Order 841 for Energy Storage Resources: Manual 28 and Manual 27 Revisions

Andrew Levitt
Senior Business Solutions Architect
Applied Innovation
June 20, 2019
Market Settlements Subcommittee

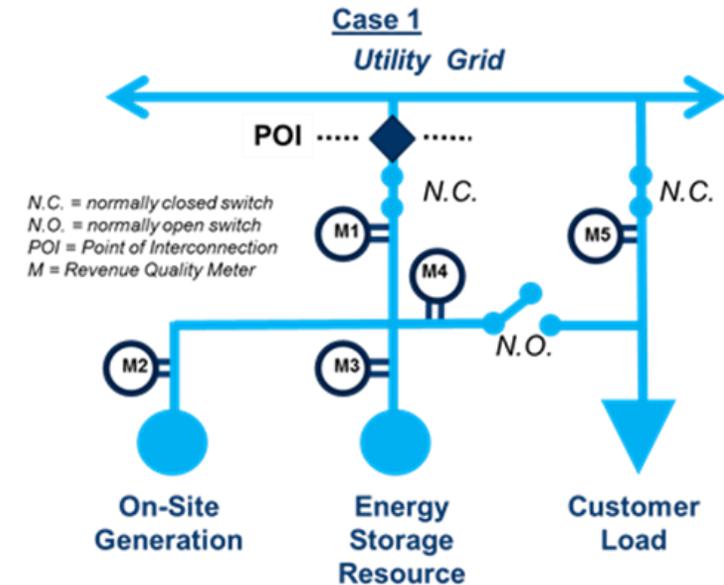
“In any given month, all energy withdrawn from the grid from the Point Of Interconnection meter shown as “M1” in Figure XXX above is Direct Charging Energy, except that meter “M4” appropriately measures the quantity of monthly Load Serving Charging Energy. Load Serving Charging Energy is withdrawn from the grid, stored in the Energy Storage Resource, then provided to end use loads, and is therefore not Direct Charging Energy.”

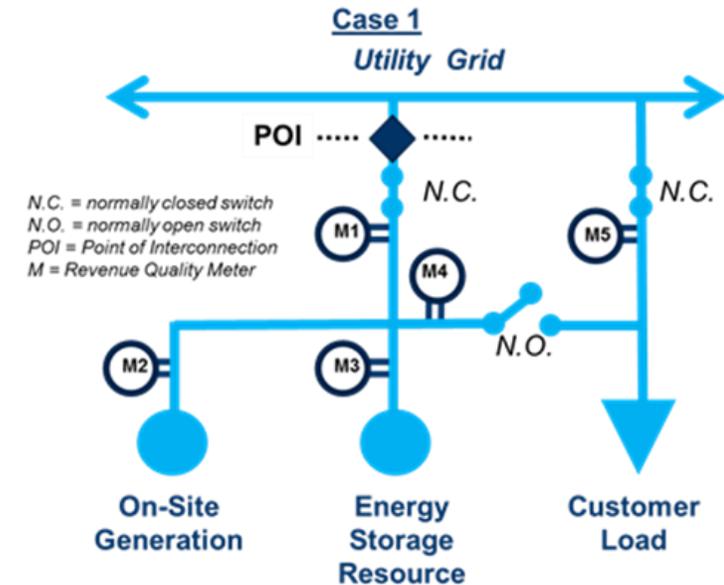
“In any given month, all energy withdrawn from the grid from the Point Of Interconnection meter shown as “M1” in Figure XXX above is Direct Charging Energy, except that any Load Serving Charging Energy that is withdrawn from the grid is not Direct Charging Energy. In this case, the Energy Storage Resource can charge from the grid or from the on-site generation. The quantity of the Energy Storage Resource inventory that is discharged to the end user that consists of energy originally withdrawn from the grid constitutes Load Serving Charging Energy. If the Electric Distribution Company determines that the Energy Storage Resource inventory that is discharged to the end user consists entirely of stored on-site generation, then no Load Serving Charging Energy was consumed by the end-use load. An appropriate method to make such a determination is to compare the monthly energy production from the on-site generation as measured at meter “M2” in above figure XXX with the monthly quantity of energy provided to the end-use customer through meter “M4”—if “M2” monthly quantity is greater than the “M4” monthly quantity, then no Load Serving Charging Energy was consumed.”

22.4: Case 2: Load Co-Located with Energy Storage Resource

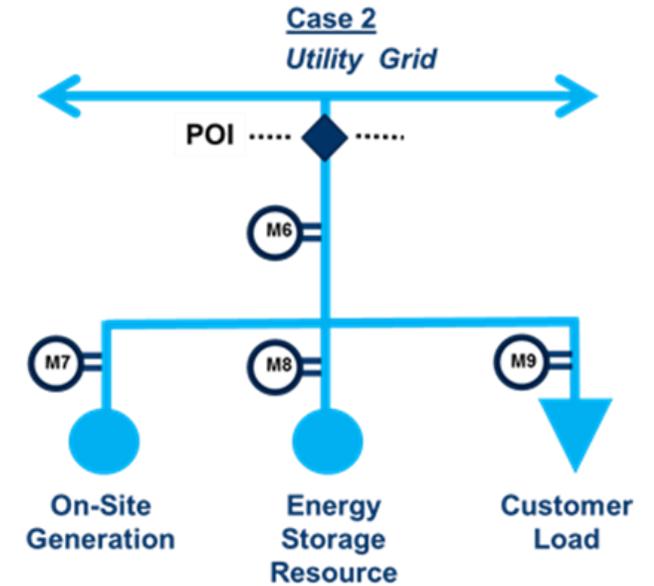
“PJM can accommodate Energy Storage Resources co-located with end-use load (as shown in Case 2 of Figure XXX above) using a “virtual buy all/sell all” approach. In such cases, the Energy Storage Resource transacts 100% of its energy at wholesale with PJM by relying on energy measured at meter “M8”.”

“Alternatively, PJM can accommodate Energy Storage Resources co-located with end-use load using a “net excess sale” approach. In this case, injections at meter “M6” are wholesale sales by the Energy Storage Resource, while withdrawals at “M6” are a mix of retail purchases by the host retail customer (with corresponding purchases by a Load Serving Entity from the PJM energy market) and purchases of Direct Charging Energy by the Energy Storage Resource. In any given month, all energy withdrawn from the grid from the Point Of Interconnection meter shown as “M6” in Figure XXX above is ordinary load (purchased by a Load Serving Entity) or is Load Serving Charging Energy, except for any Direct Charging Energy. Monthly energy injected onto the grid as measured at meter “M6” appropriately identifies the monthly quantity of Direct Charging Energy, together with any lost energy associated with the conversion and storage of grid energy for later injection onto the grid. The Energy Storage Resource may report such losses to PJM through PJM Power Meter, or the Electric Distribution Company may work directly with the Energy Storage Resource to quantify such losses. Direct Charging Energy is therefore the sum of monthly injections at meter “M6” plus associated losses.”
